DEPARTMENT OF HEALTH
Contested Case Hearing Re Red Hill Permit Application
19-UST-EA-01
Supplemental Testimony of Frank Kern

I have reviewed the Expert Report DNV-GL prepared under the supervision of Dr. David M. Norfleet, and provide this supplemental testimony in response to the following characterizations, opinions, and conclusions DNV-GL provided:

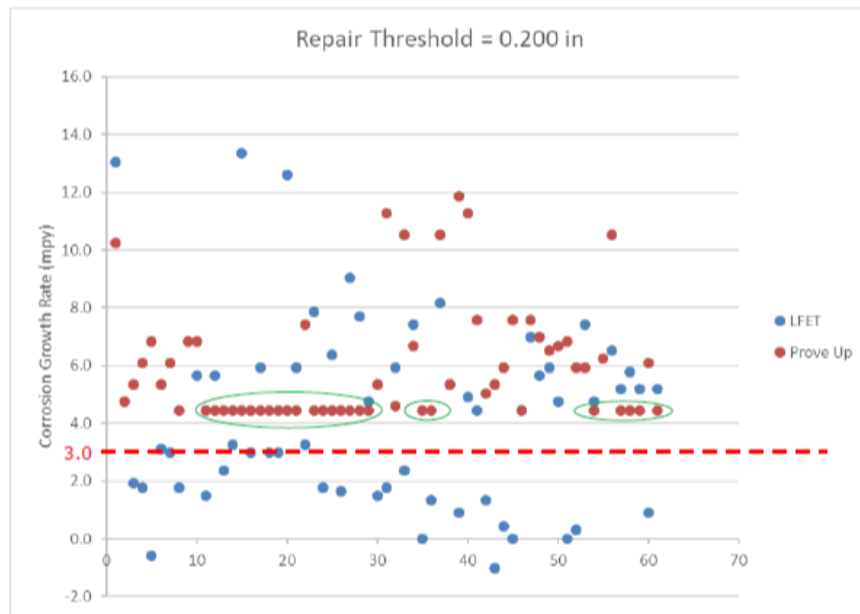
11
12 **18. Figure 16 at Page 48.**

The corrosion rates in Tank 5 presented in the DNV-GL report are based on a calculation which used an interval of 6.74 years. During warranty repairs to Tank 5, Willbros Government Services poorly performed work by overgrinding the metal. This resulted in metal loss not due to corrosion. The metal removal performed by Willbros Government Services is depicted typically in DNV-GL Figure 17 on Page 49, which shows a large area of ground metal surrounding a patch plate. 6.74 years should not be used as the corrosion rate calculation denominator in Tank 5 because the metal loss was not caused by corrosion, it was caused by a grinder. The rates reported in Figure 16 are not valid because they calculate a rate of metal loss due to corrosion when actually the metal loss was not due to corrosion.

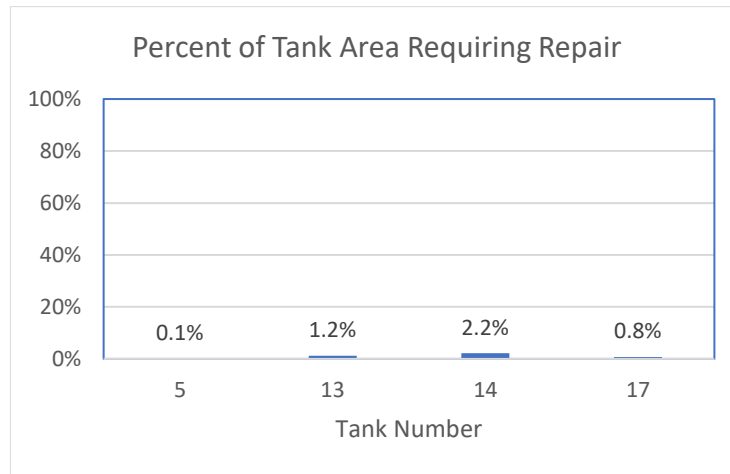
19. “DNV GL’s opinion is that the tanks are in an end-of-life phase and that a true renewal process is not occurring.” Section 3.1.6 at Page 53.

The basis for the DNV-GL opinion that tanks are at end of life condition and true renewal is not occurring, appears to be that the corrosion allowance for the steel has been exhausted. However, that opinion contradicts the principles of API Standard 653, which require a minimum bottom thickness at the end of a service interval and the use of welded-on patch plates to achieve the minimum thickness. All of the steel renewal work taking place at Red Hill is designed and approved by a licensed professional engineer with substantial experience in inspection and repair

6
7 The DNV-GL opinion that tanks are at end of life condition is not supported by the results of the
8 most recent inspection, which determined that small areas of each tank required repair due to
9 backside corrosion in Tanks 5, 13, 14, and 17. The largest area of repair was Tank 14 which was
10 2.2%, and the smallest area was Tank 5 which was 0.1%. The chart below depicts the percentages
11 of the tank area that required repair. Many other repairs are programmed for each tank in an
12 abundance of caution. However the repairs due to backside corrosion, which is the progressive-
13 type of damage that requires repair to renew the liner steel, is taking place in relatively small areas.
14 Thus, the opinion that renewal is not taking place and that tanks are in end-of-life condition is
15 inconsistent with recent inspection information.
